## TRI-PARTY AGREEMENT

Change Notice Number TPA-CN- 0882	TPA CHANGE NOTICE FORM	Date: 12/16/19
Document Number, Title, and Revision: DOE/RL-2016-22, <i>Waste Management Plan for Perched Water Pumping/Pore Water Extraction, 200-DV-1 Operable Unit, Rev. 0</i>		Date Document Last Issued: March, 2016
Approved Change Notices Against this Document:		
Originator: Mark Byrnes		Phone: 509-373-3996

**Description of Change:**  
DOE/RL-2016-22 is revised to add twelve new wells planned to support perched water extraction and monitoring in the 200-DV-1 Operable Unit.

Figure 1. 200-DV-1 OU Perched Water Pumping/Pore Water Extraction Site in the B Complex Area

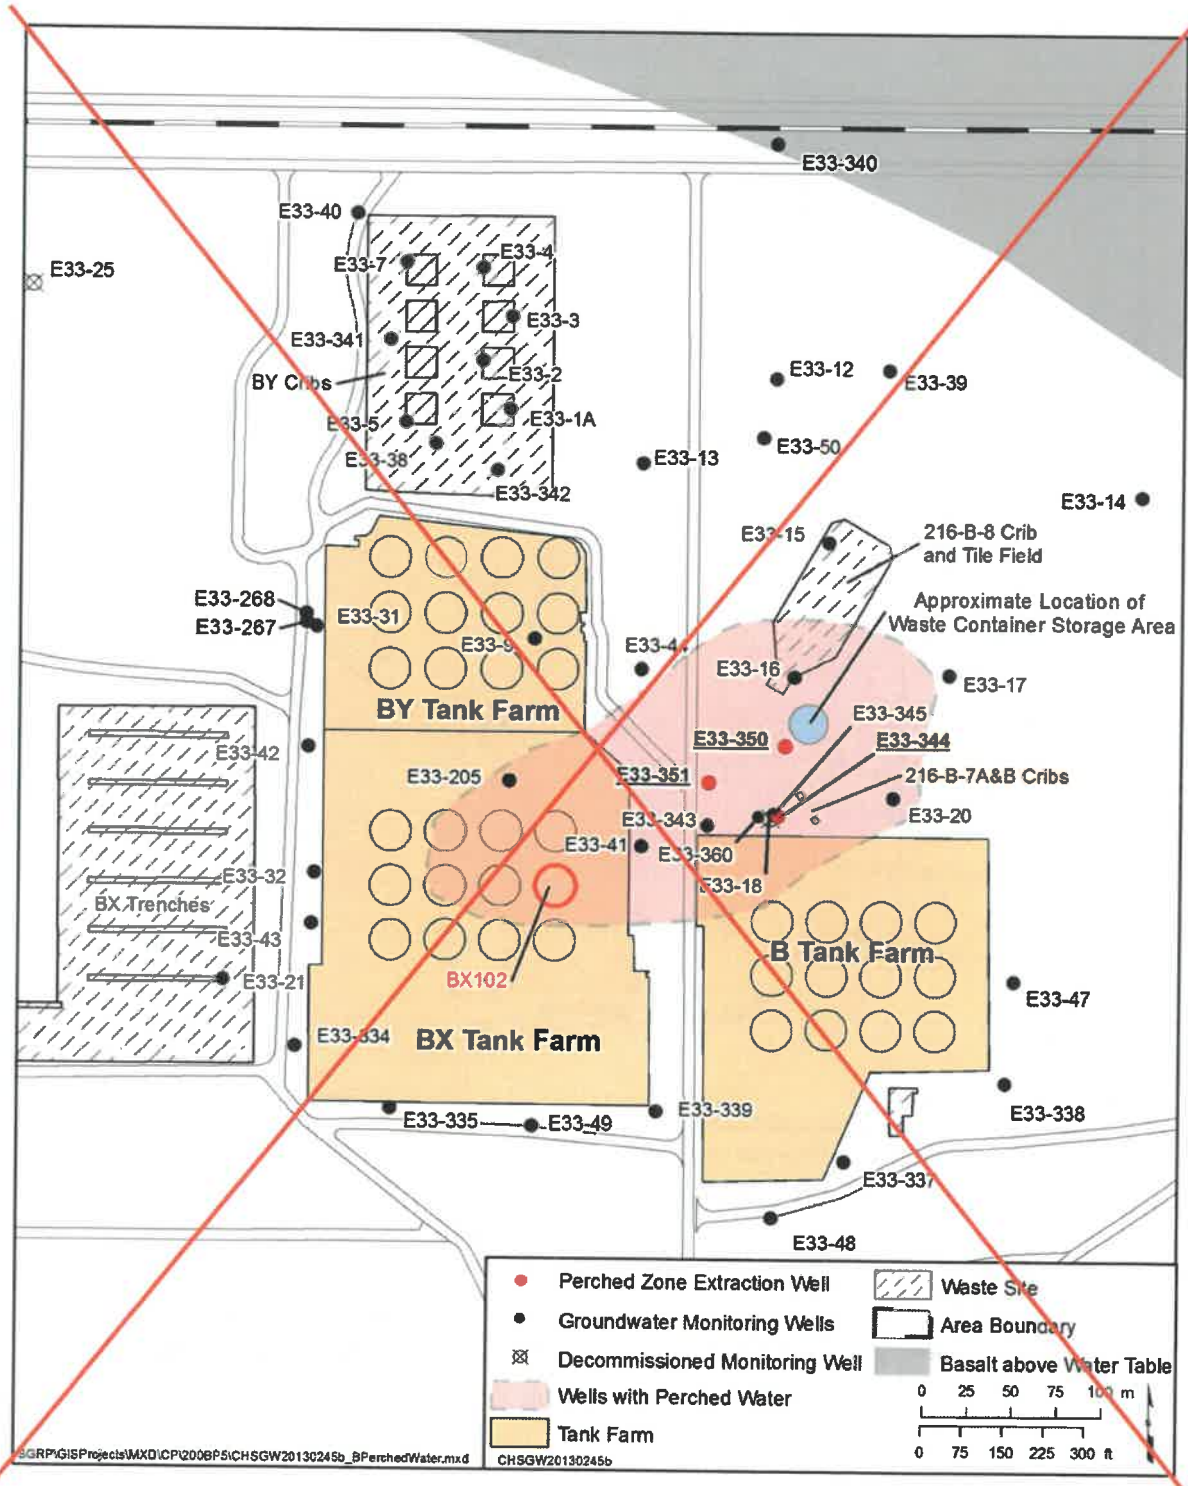
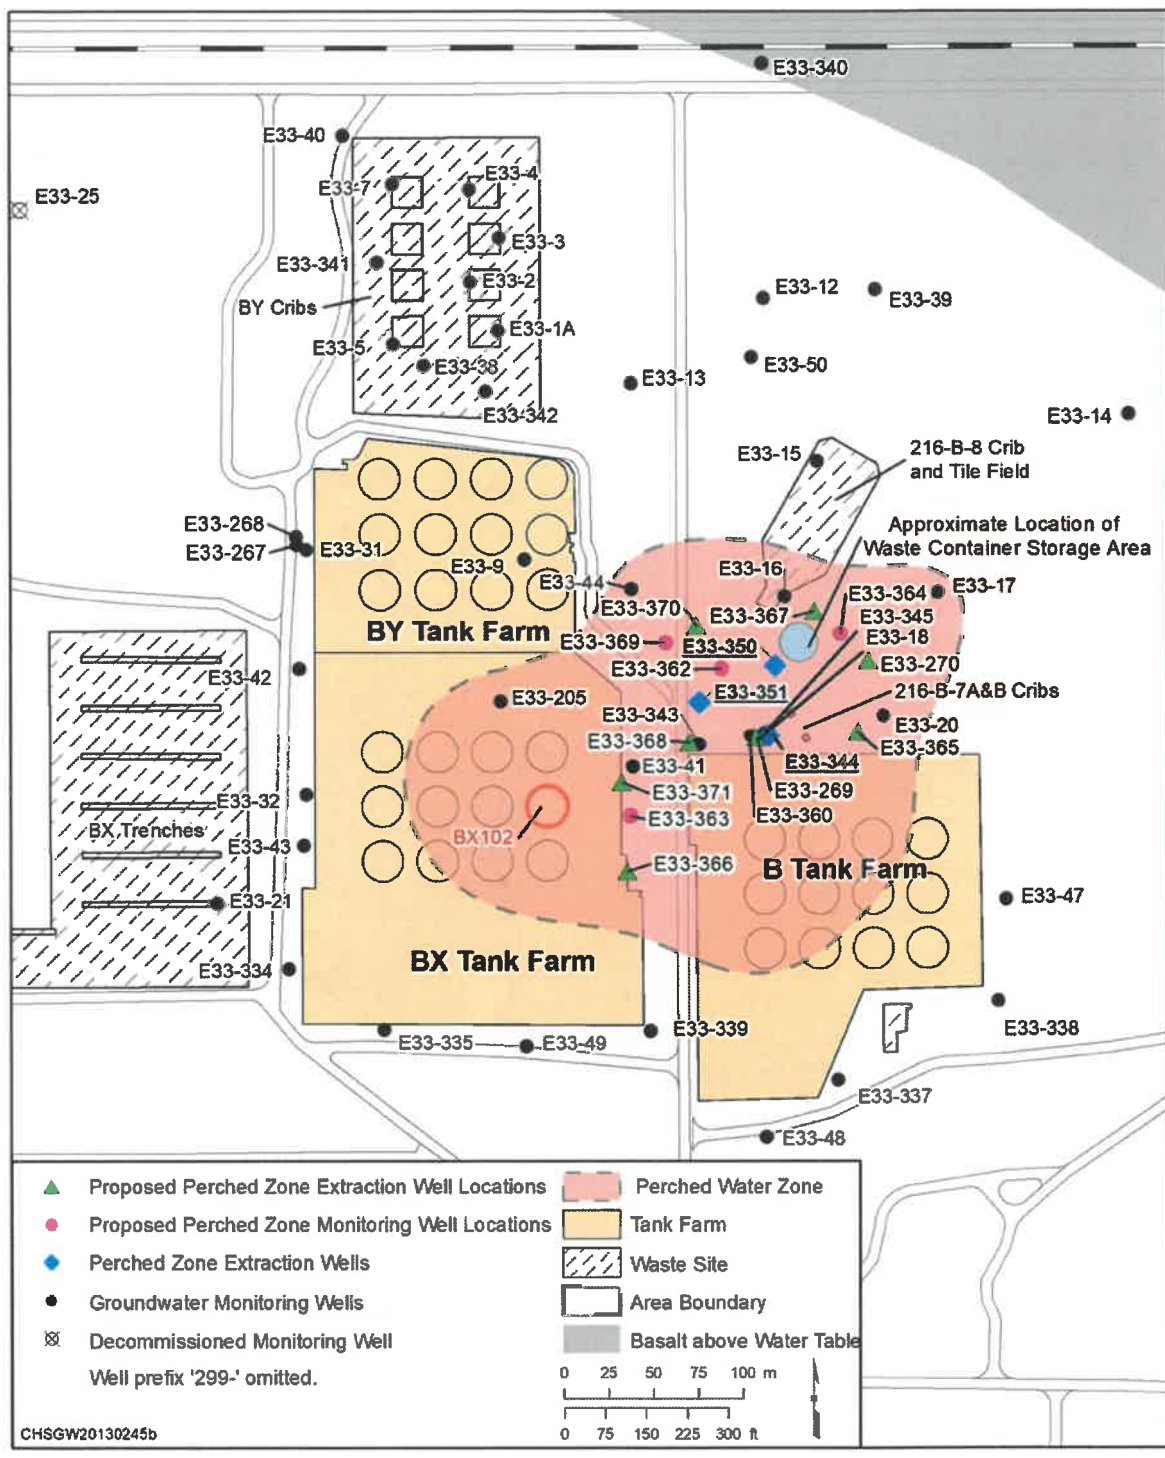
Page 5, Figure 1 is modified to add the twelve proposed new wells and to show the revised extent of the perched water zone.
